Response Letter to Village Comments Round 3

Response to the follow Questions are listed below with pictures for reference

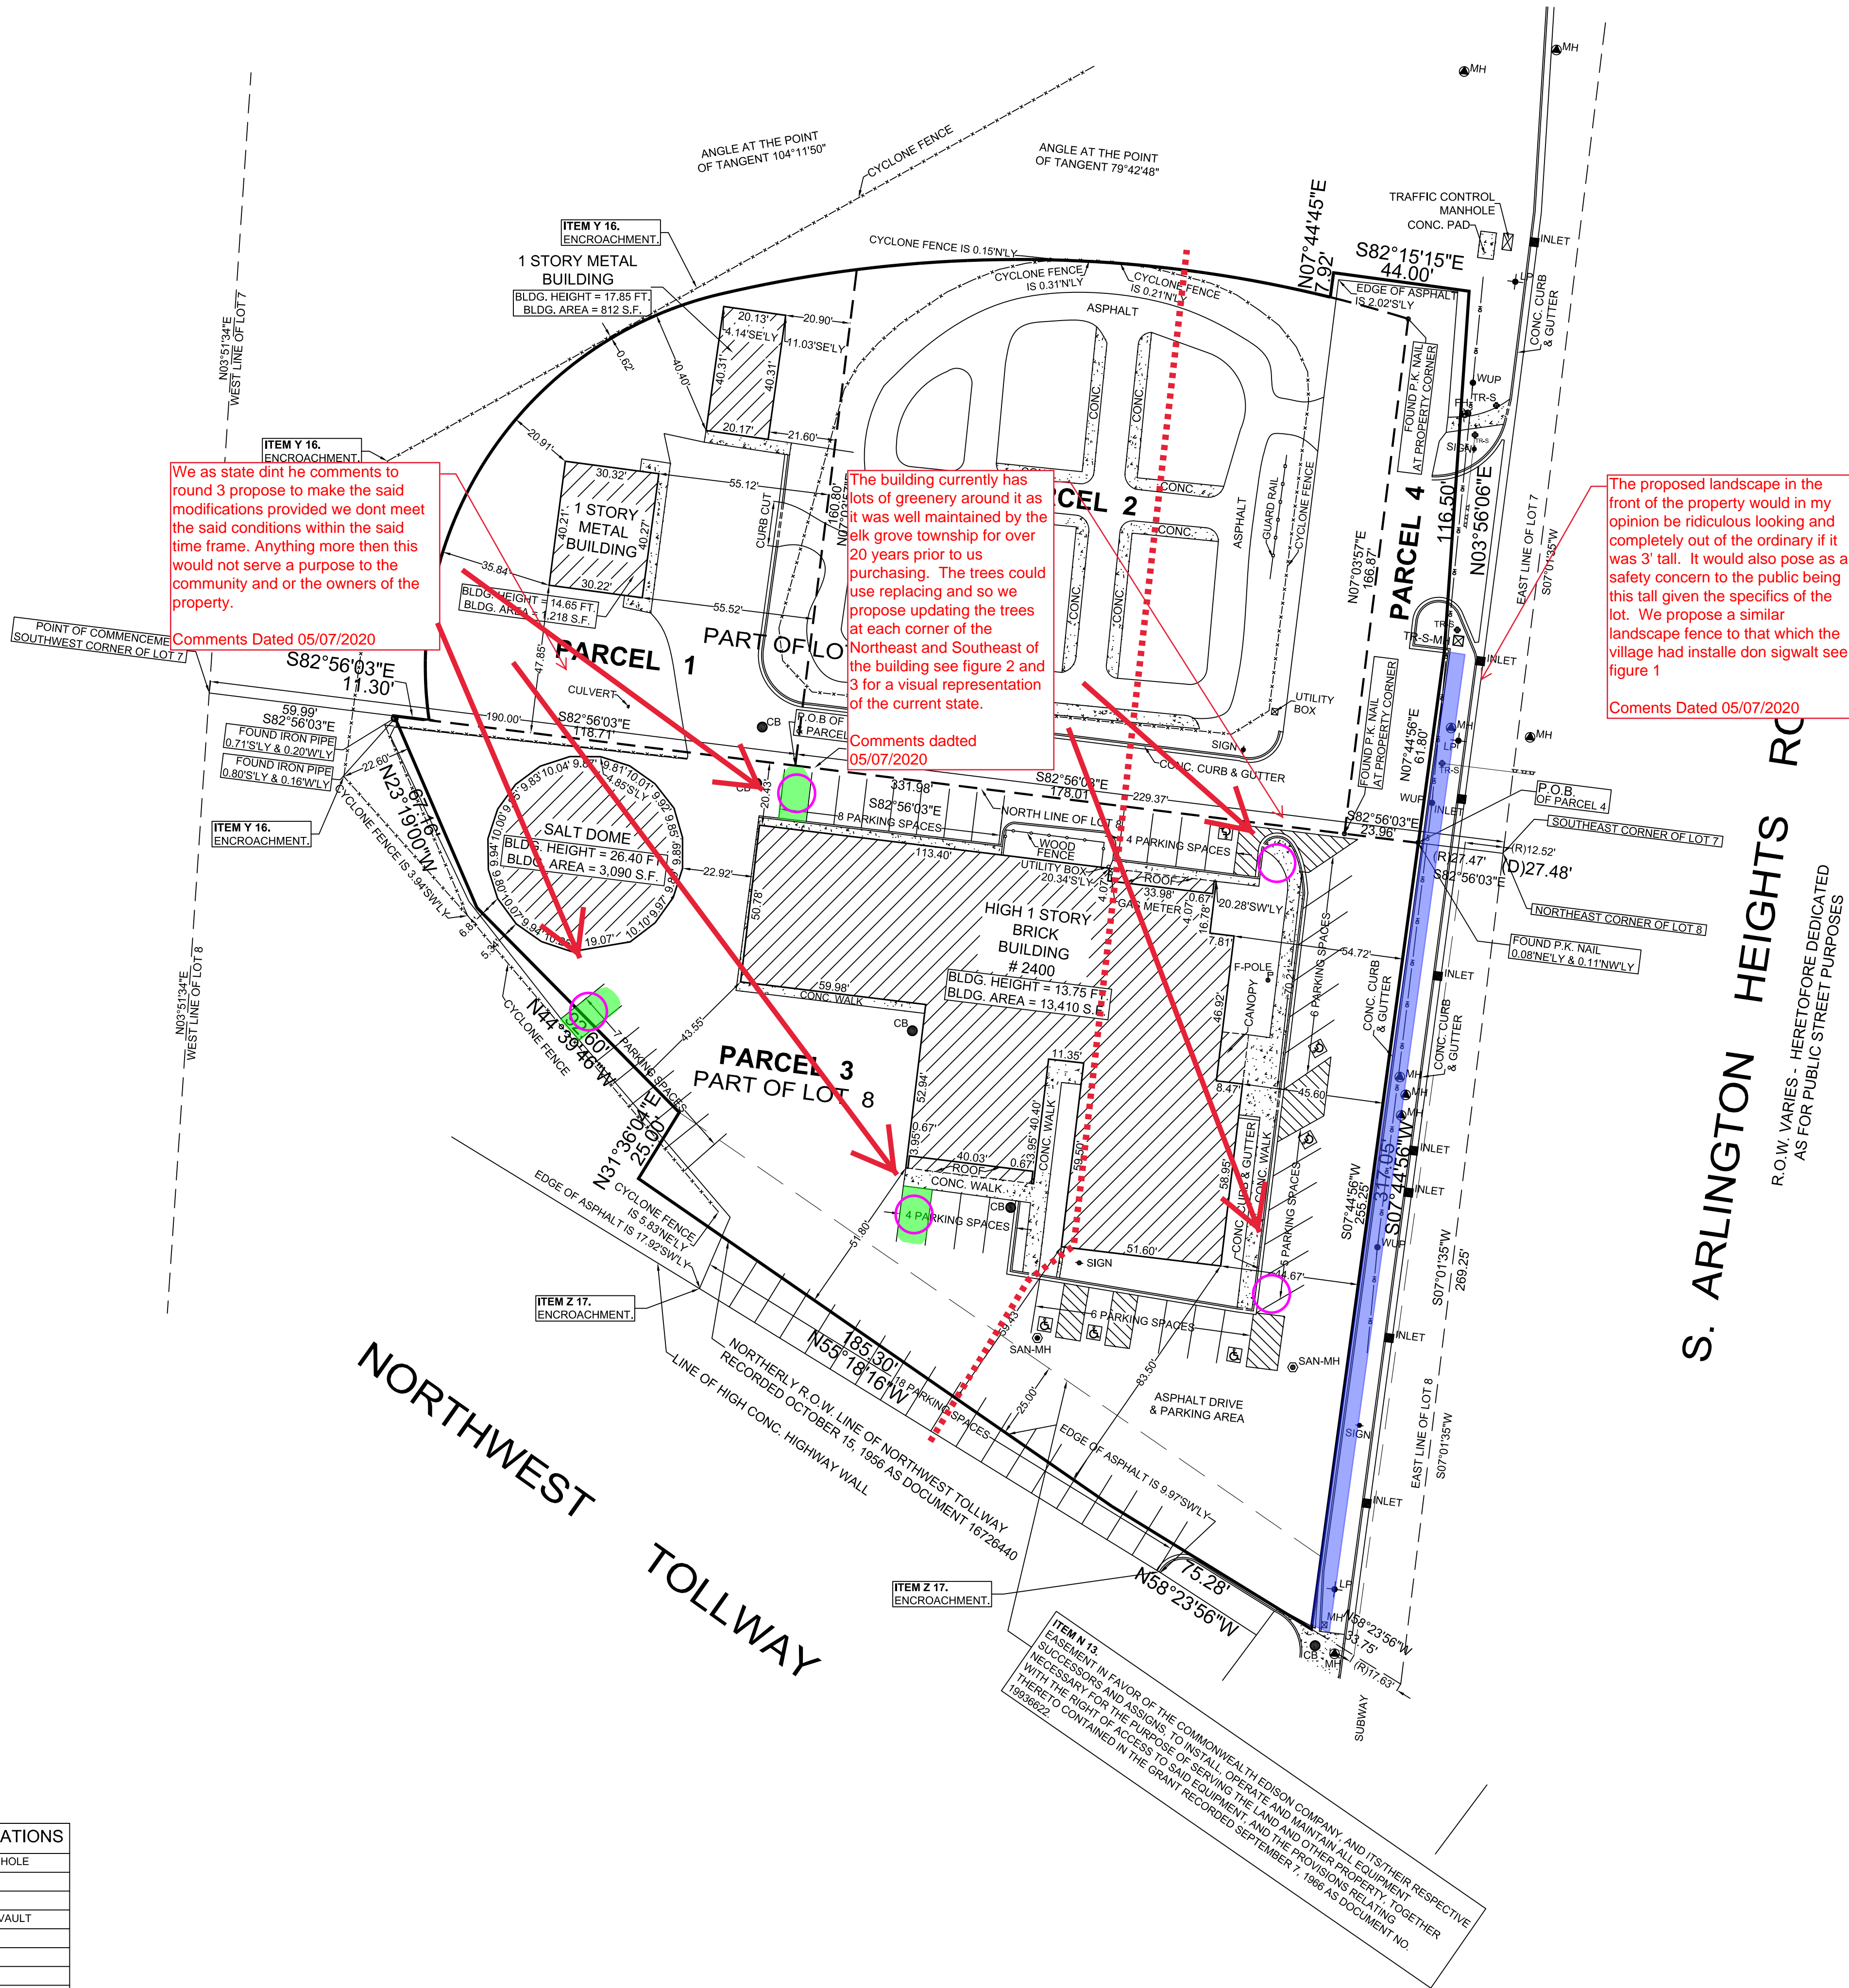
Phase II of the landscape would be conditional on the fact that if we do not present to the village a comprehensive plan for redevelopment by September 20, 2023 then we would proceed with the proposed phase II landscape. See attached revised survey with the proposed landscape work. This phase would only be implemented in the event that we do NOT present a comprehensive plan for complete redevelopment by September 20, 2023. In the meantime Phase I will be implemented within 24 months of this approval process.

Please see exhibit B for a representation of the proposed landscape

3' Tall Parking Lot Landscape Screen

Landscape Island

4" Caliper Shade Tree

Phase I/Phase II delineation. Improvements to the east of this line must be installed no later than 24 months from the approval of the rezoning. Items to the west of this line must be installed no later than September 20, 2023 only in the event that a comprehensive plan for redevelopment has not been submitted to the village prior to this date..
